CARLISLE - HANNETT PEDESTRIAN CROSSING CONSTRUCTION MODIFICATIONS

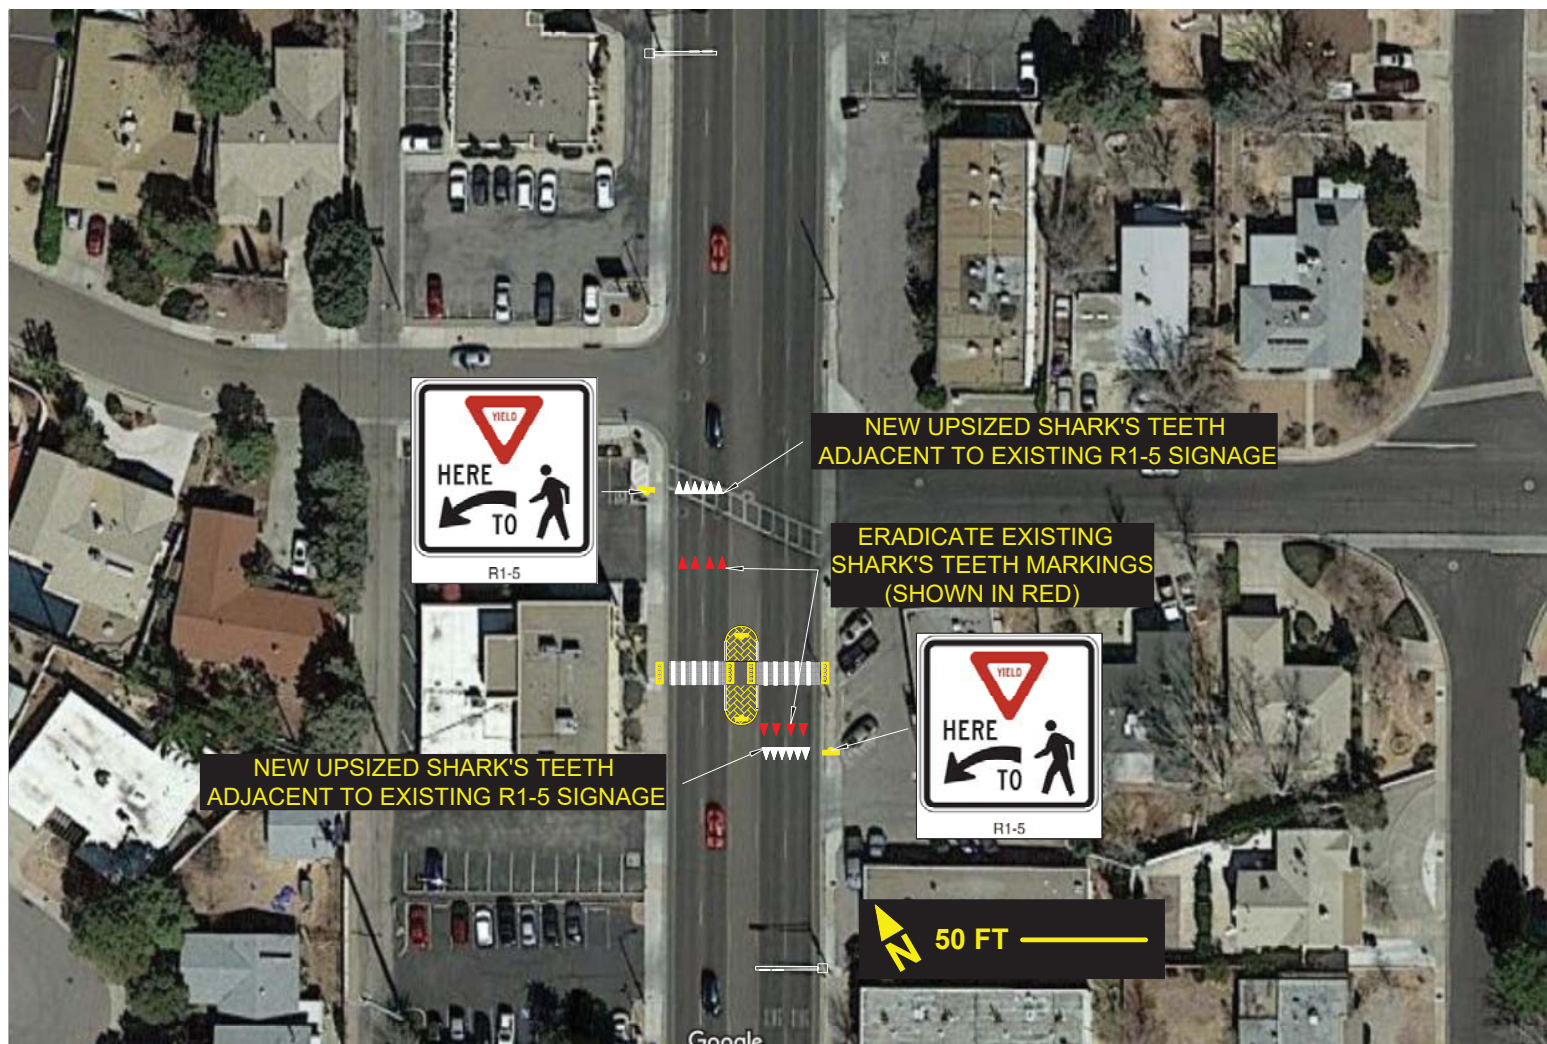
- Current "Shark's Teeth" markings to be eradicated and replaced with 24" x 36" shark's teeth that are adjacent to existing R1-5 signage. Preformed thermoplastic must be utilized.
- Confirm proposed layouts and locations with City PM before placement.
- CPN 647111
